STATE OF WASHINGTON
DEPARTMENT OF HEALTH
SOUTHWEST DRINKING WATER REGIONAL OPERATIONS
P.O. Box 47823 Olympia, Washington 98504-7823
TDD Relay 1-800-833-6388

August 1, 2016 Mont Jeffreys, Manager Hartstene Pointe Water-Sewer District 772 East Chesapeake Drive Shelton, Washington 98584	Hartstene Pointe ID #31569	
	County:	Mason
	System Type:	Community
	Operating Permit Color:	Green
	Surveyor:	Regina Grimm
	Inspection Date:	July 21, 2016

Thank you for meeting with me to conduct a survey of this water system. Sanitary surveys are the Office of Drinking Water's (ODW) way to inspect public water systems through a field visit. ODW is also able to offer technical assistance to help utilities improve their system operations and ensure that public health is protected.

Well #2 Filtration Vessels

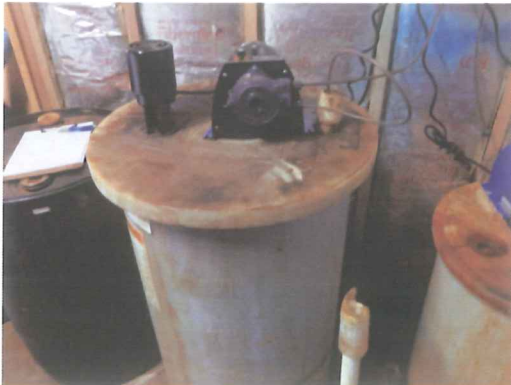
Because of the reduced production from Well #1 the system has been using Well #2 as the primary source. A major problem with the Well #2 plant is that the filter media is spent and they are having to backwash extremely frequently. To get adequate removal of arsenic the ferric chloride dose needed to be increased and the backwash frequency was decreased from every 3 hours to every 6 hours. Unfortunately, this has reduced the effectiveness of arsenic removal. The running annual average for arsenic as of June 2016 is 8.2 mg/L, which is less than the MCL. However, when there are four or more exceedances within a 12 month period this is classified as a treatment technique violation and public notification is required. The monthly lab samples taken in September 2015, November 2015, May 2016, and June 2016 have exceeded the arsenic MCL.

The operator does not have a test kit for measuring the ferric chloride and he does not have a target dosage. The system needs to calculate the dosage being used and measure the residual. I checked with Stephen Baker, our treatment specialist in ODW Headquarters, for his recommendations. He said that arsenic treatment plant operators should be testing pre- and post-filtered iron levels on at least a weekly basis. Results will reflect both the background level, plus the added dose, less what is removed through filtration. The applied ferric chloride dose can be calculated from a feed pump drawdown test, knowing plant flow rate and feedstock strength (i.e. a standard pump calibration). For guidance on doing these calculations I recommend contacting Stephen Baker at (360) 236-3138 or by e-mail at stephen.baker@doh.wa.gov. **The system should develop a way to verify and record the ferric chlorine dosages.**
